# Amendment C155 to the Glen Eira Planning Scheme

East Village Development, Bentleigh East  
Expert Witness Report

Prepared by: GTA Consultants (VIC) Pty Ltd for Glen Eira City Council

Figure 2.1: Alternate layout for North Road / Crosbie Road / Cobar Street intersection

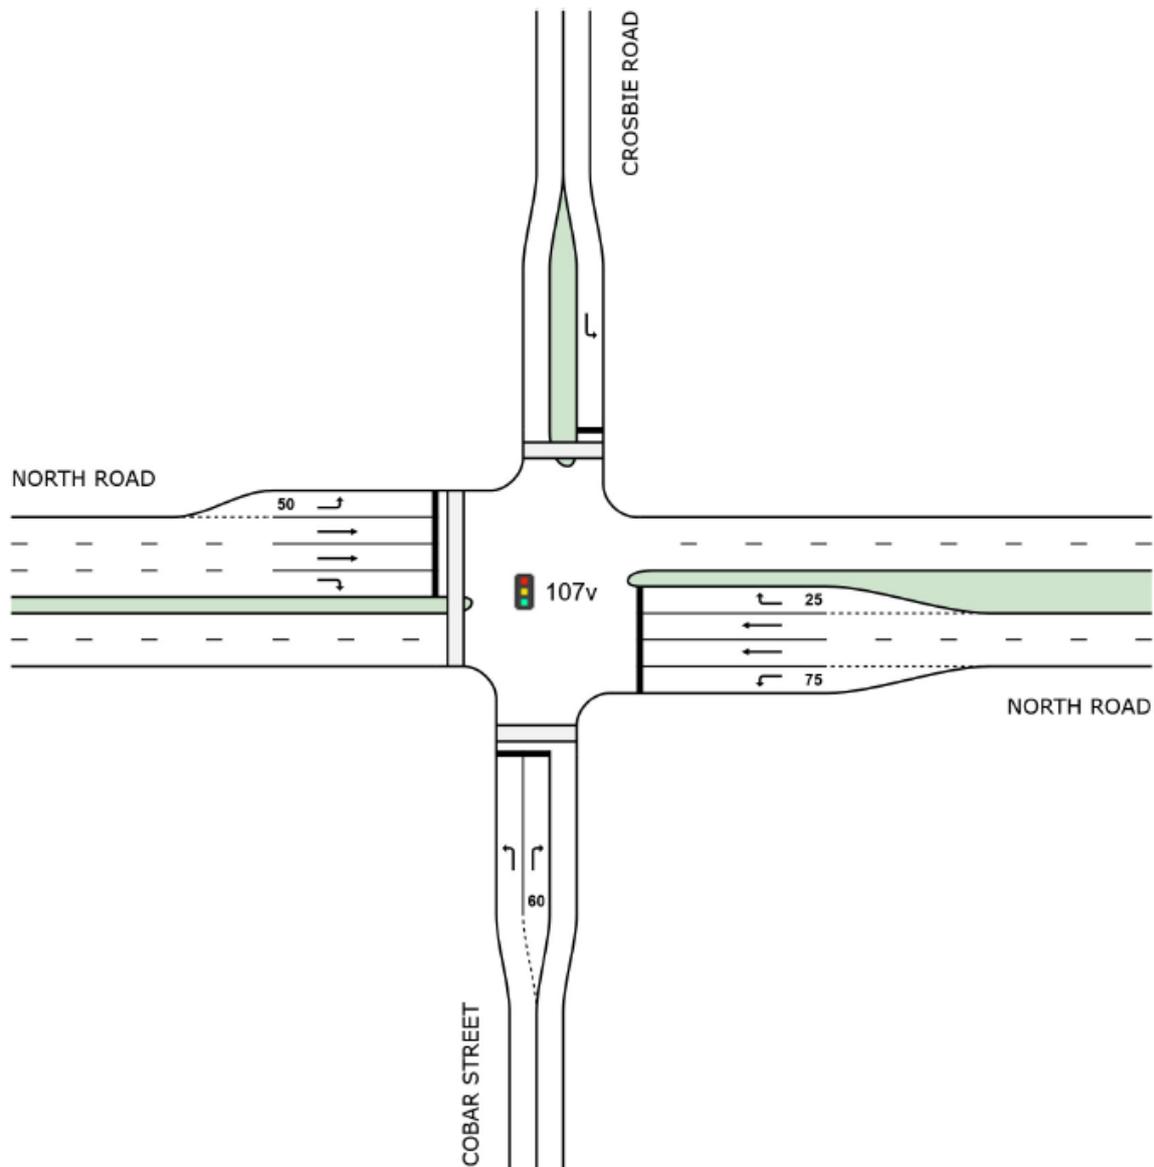
In my opinion it would be reasonable for traffic previously assumed to travel north up Crosbie Road from Cobar Street to instead turn right into North Road to access alternate north-south routes such as Poath Road and/or Warrigal Road. I have undertaken this analysis and can confirm that the North Road / Cobar Street / Crosbie Road will continue to operate appropriately with the above change in traffic distribution with a DOS of 0.82 during the AM peak hour and 0.81 in the PM peak hour with the results provided at Appendix C. It is noted that the analysis also includes the extension of the left turn lane on North Road (east) and the provision of a left turn lane on North Road (west) as recommended in the Department of Transport submission. The intersection layout is provided below in Figure 2.1:

Subject to the pedestrian phase across Crosbie Road not operating when traffic is turning right out of Cobar Street, it is considered that appropriate regulatory signage and linemarking would be sufficient to achieve the desired outcome of minimising additional through traffic using Crosbie Road.

Notwithstanding, it is recommended that the intersection design be modified to as far as practicable to physically discourage vehicles from travelling north up Crosbie Road to support the regulatory signage and linemarking.

EAST VILLAGE DEVELOPMENT  
NORTH ROAD AND MURRUMBEENA ROAD  
SIGNALISED INTERSECTION  
CONCEPT LAYOUT (DBYD SERVICES UNDERLAY)  
DRAWING NO. V136080-04-04 SHEET 4 OF 12 ISSUE P2

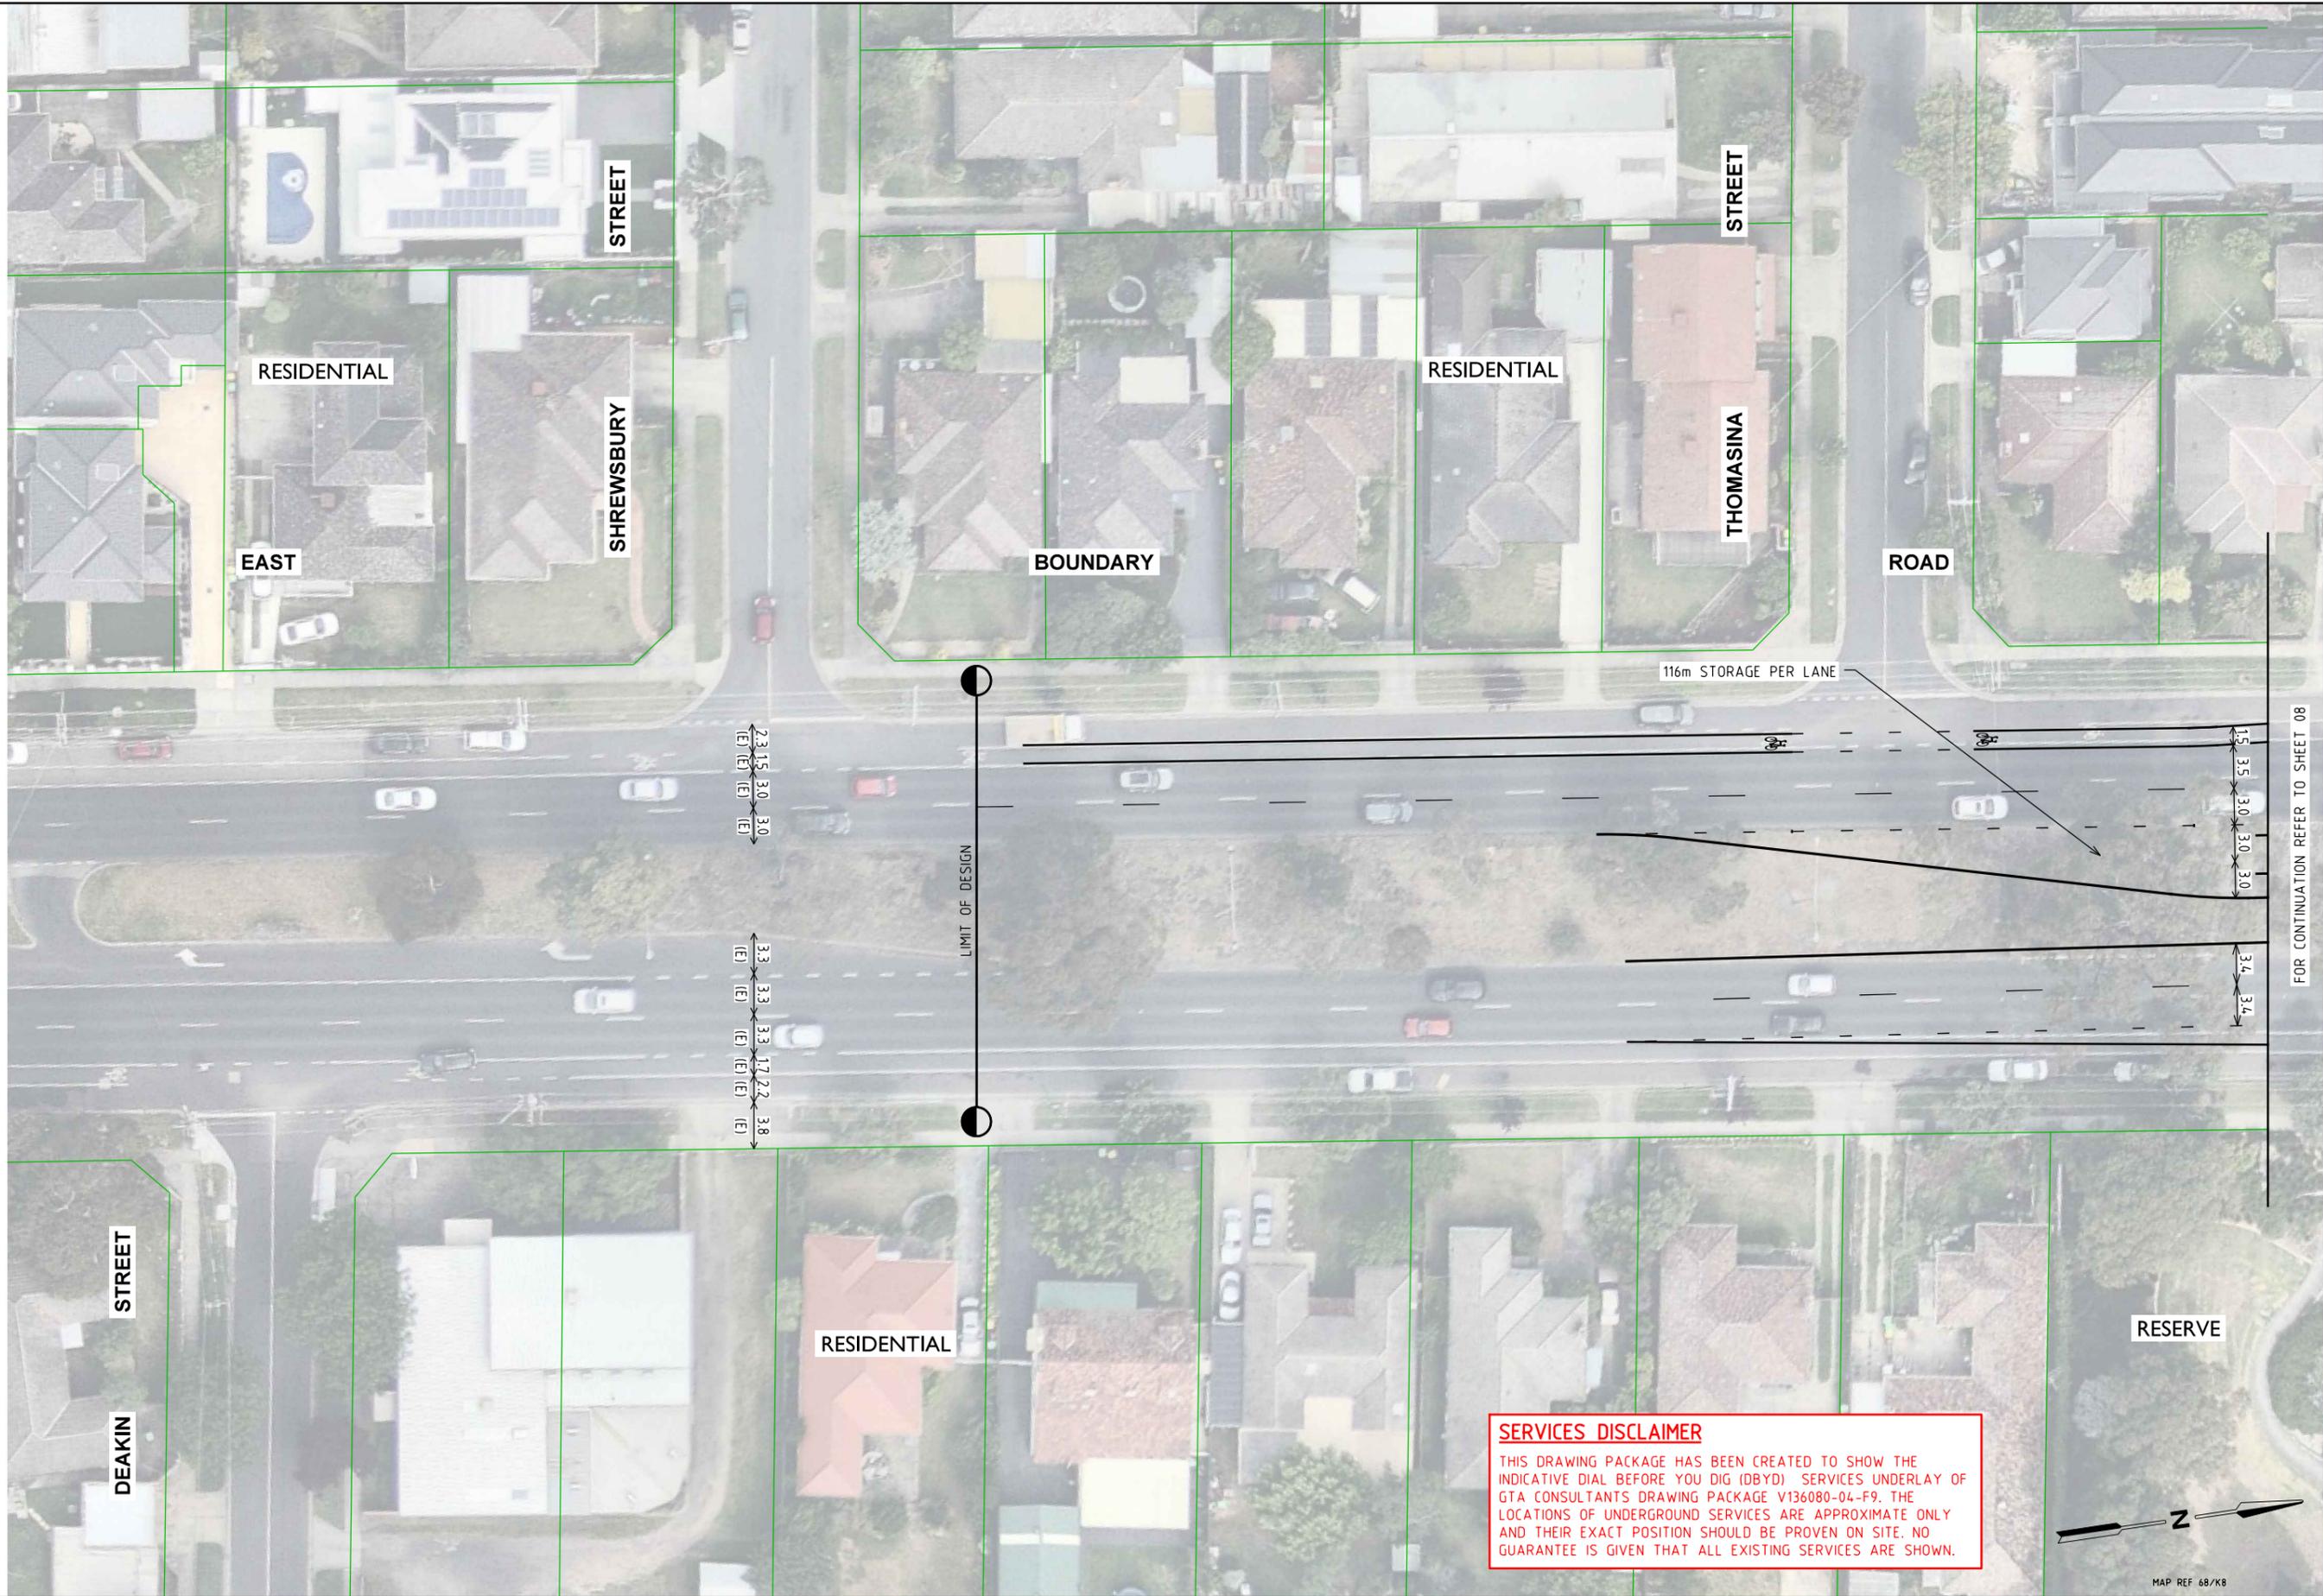
In reviewing the concept level design layouts included in Appendix D of the GTA 2018 report, I have observed that the extent of works on North Road to the west and East Boundary Road to the south does not match the proposed mitigating measures set out in Section 5.4 and Appendix C of the GTA 2018 report. Specifically, the following variations are noted:

- The third southbound lane on East Boundary Road is required to only extend for 60m south of South Drive whereas the concept layout has the lane extending to Parkmore Road which is located approximately 400m south of South Drive.
- The third westbound lane on North Road is required to only extend for 150m west of East Boundary Road whereas the concept layout has the lane extending to Koornang Road which is located approximately 680m west of East Boundary Road.

It is recommended that the concept level design layouts be amended to reflect the proposed mitigating measures as set out in Section 5.4 of the GTA 2018 report. I have prepared an amended plan for the above alterations which is provided at Appendix B.
